UNITED STATES
NUCLEAR REGULATORY COMMISSION
WASHINGTON, D.C. 20555-0001

SUBJECT: SUMMARY OF APRIL 25, 2017, MEETING WITH EXELON GENERATION COMPANY, LLC, ON PLANNED SUBMITTAL OF LICENSE AMENDMENT REQUEST TO CHANGE EMERGENCY ACTION LEVELS ASSOCIATED WITH LAKE ONTARIO WATER LEVEL

SUBJECT: License Amendment Request – Change Emergency Action Level HU1.5 to Remove High Lake Level Initiating Condition for Unusual Event Emergency Classification

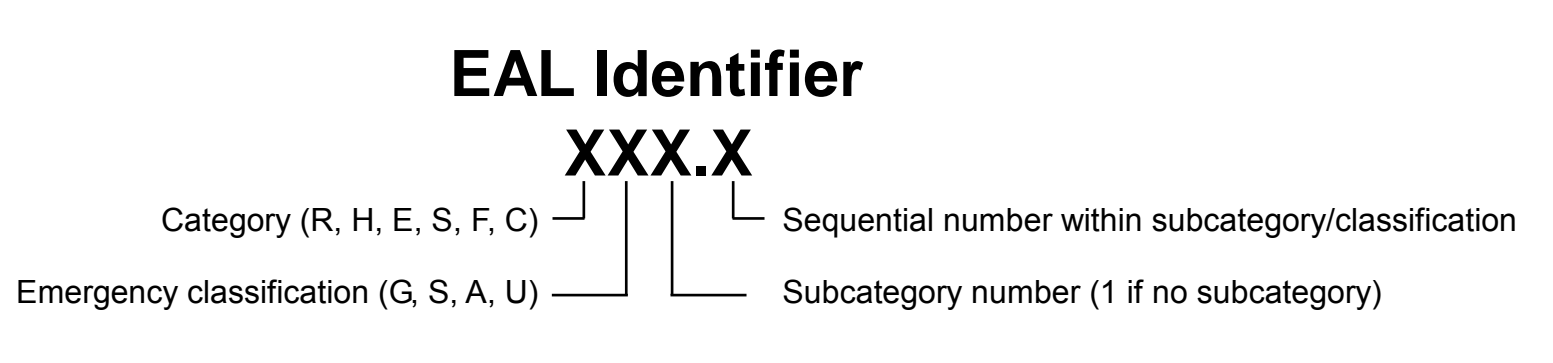
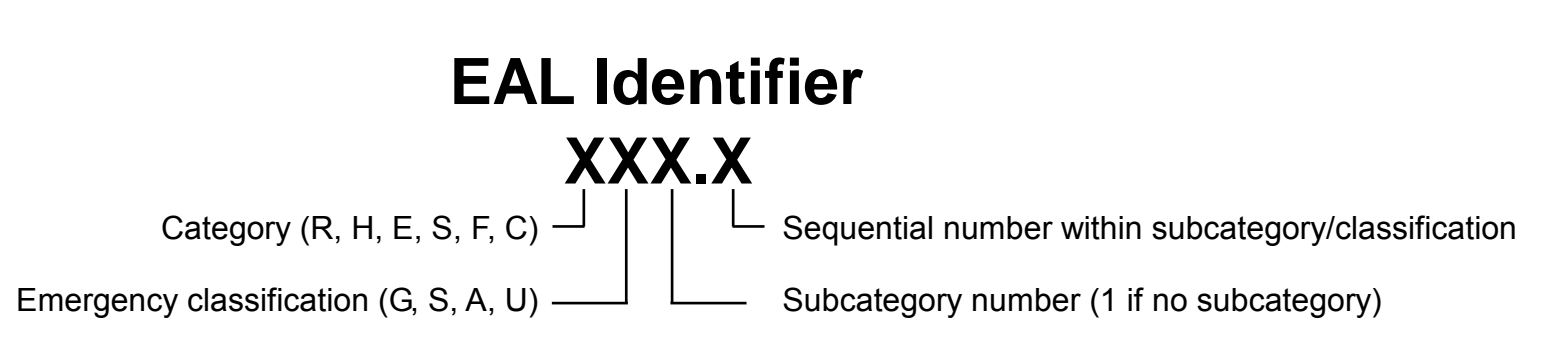
The proposed change to the NMP1 and NMP2 EALs (EP-AA-1013, Addendums 3 and 4), is to delete the Notice of UE threshold for high lake water level as provided in Recognition Category H - Hazards and Other Conditions Affecting Plant Safety, EAL HU1.5. See proposed changes to the EAL and EAL Basis shown below.

Exelon proposes to revise the HU1.5 EAL threshold to remove the UE maximum lake level threshold. NMP site utilizes Operating Procedures to monitor the lake level twice daily. Changes to lake level occur incrementally and large changes occur over extended periods of time. Observed changes/trends are communicated to Station Management for review and appropriate actions. The IJC also provides predictions for significant lake level changes. Station Management is alerted and has opportunity to evaluate trends as the "Alert" EAL threshold is approached.
